ELLERAY HALL PLANNING APPLICATION ASSESSMENT AGAINST RICHMOND LOCAL PLAN POLICY

Former North Lane Depot, East Car Park & Elleray Hall Day Centre, Middle Lane

Planning application 21/2533/FUL was submitted by the London Borough of Richmond upon Thames ('LBRuT') on the 8th July 2021, with further reports and drawings submitted subsequently. It was then validated on the 6th August. The description of development given by LBRuT, the local planning authority ('LPA') is:

Image 1: Sunlight and Daylight Assessment (Neighbouring Properties), Appendix 1

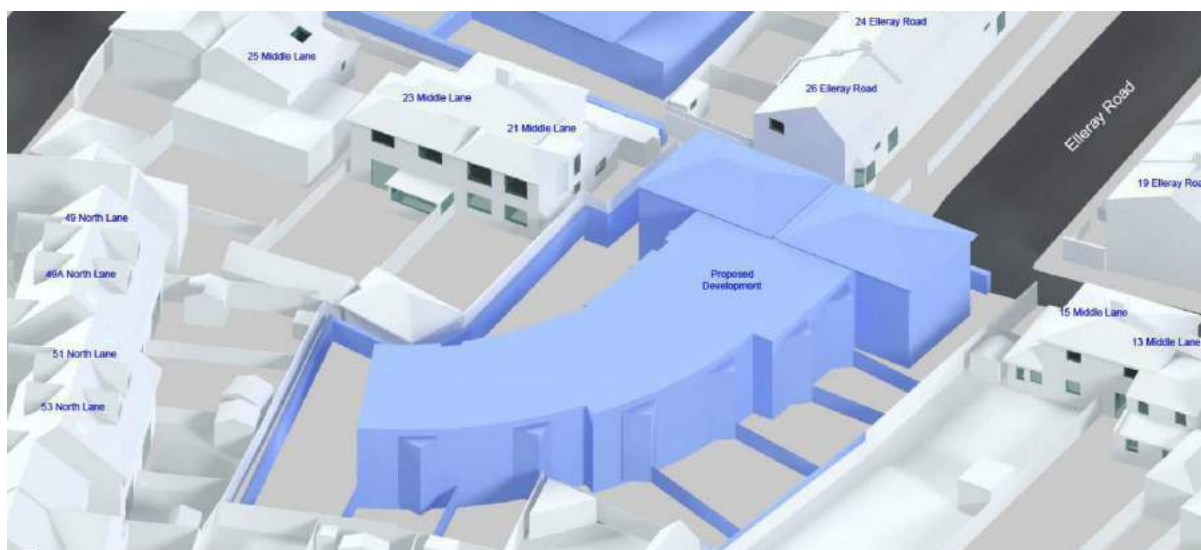
Image 1 overleaf reproduced from the Sunlight and Daylight Assessment of Neighbouring Properties prepared by Right of Light Consulting leaves no doubt about both the bulk of the proposed building and its proximity to numerous neighbouring properties and gardens. It is visually intrusive and overbearing.

Proposed Roof Plan (illustrating Solar Panels) (Clive Chapman Architects)

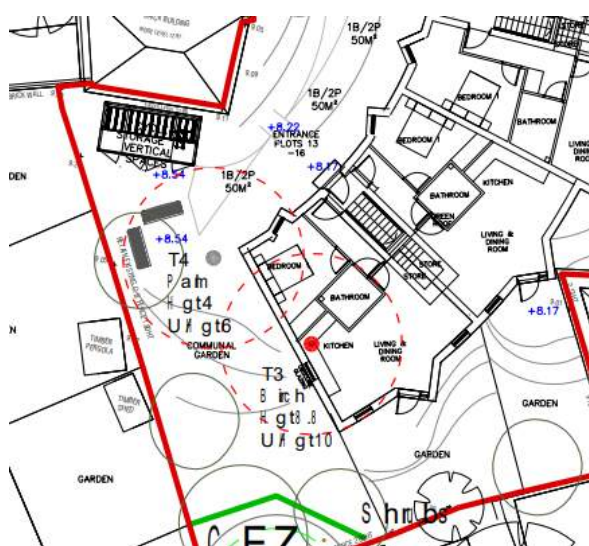
A total of 45 PV arrays is proposed. The Sustainability and Energy Report justifies not making maximum use of solar panels on site as follows:

This is considered an optimal balanced proposal for the scale and location of development, whereas an additional exercise showed that maximum number of PV arrays of 83no. could be incorporated at the full extent of roof surface available achieving -86.7% on-site CO2 offset via renewables. In this scenario the monetary contribution would be less and larger investment in technology would be imposed on developers.

The Proposed Roof Plan (see overleaf) confirms that a large amount of space would be available for additional solar provision. The Council has missed the opportunity to showcase best practice above and beyond planning policy requirements. The importance of this has been elevated by the Intergovernmental Panel on Climate Change report published on 9th August, and further to the climate emergency declaration by LBRuT:

If 83 PV arrays can be incorporated on-site, then they should be, LBRuT should not be able to pay itself out of this, or is this case of Richmond preaching but not acting.
